# AXC F 2152 – CHANGE NOTES

## Change notes for the AXC F 2152 controller

Application note  
108427\_en\_14

This document contains all changes made between firmware version 1.0.0 and the current firmware version of the AXC F 2152 controller (Order No. 2404267).

#### Left-alignable INTERBUS master

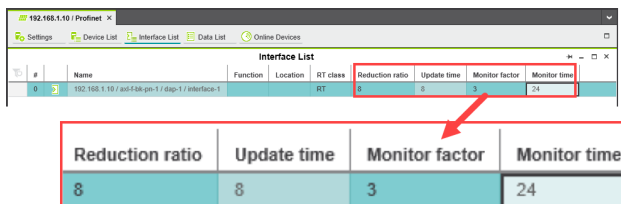
The controller now supports left-alignment of the INTERBUS AXC F XT IB master (Order No. 2403018).

Figure 2 Select Trigger task

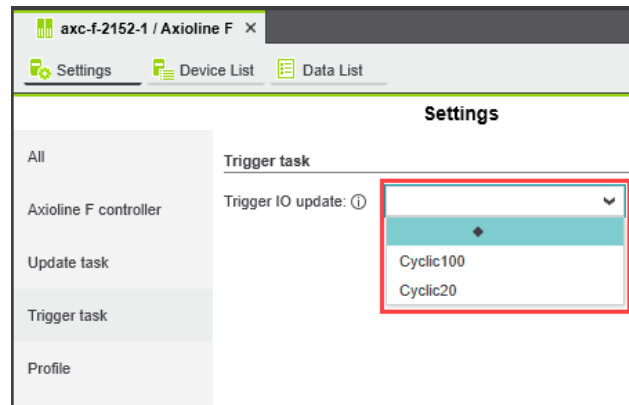
You can now specify the refresh interval for Axioline F I/O data. This is done by selecting which task triggers the Axioline F I/O data update in the PLCnext Engineer project.

- Select the “Trigger task” view in the “Settings” editor.
- In the drop-down list, select the task that is to trigger the Axioline F I/O data update.

If you do not select a task, the update will occur by default every 50 ms.
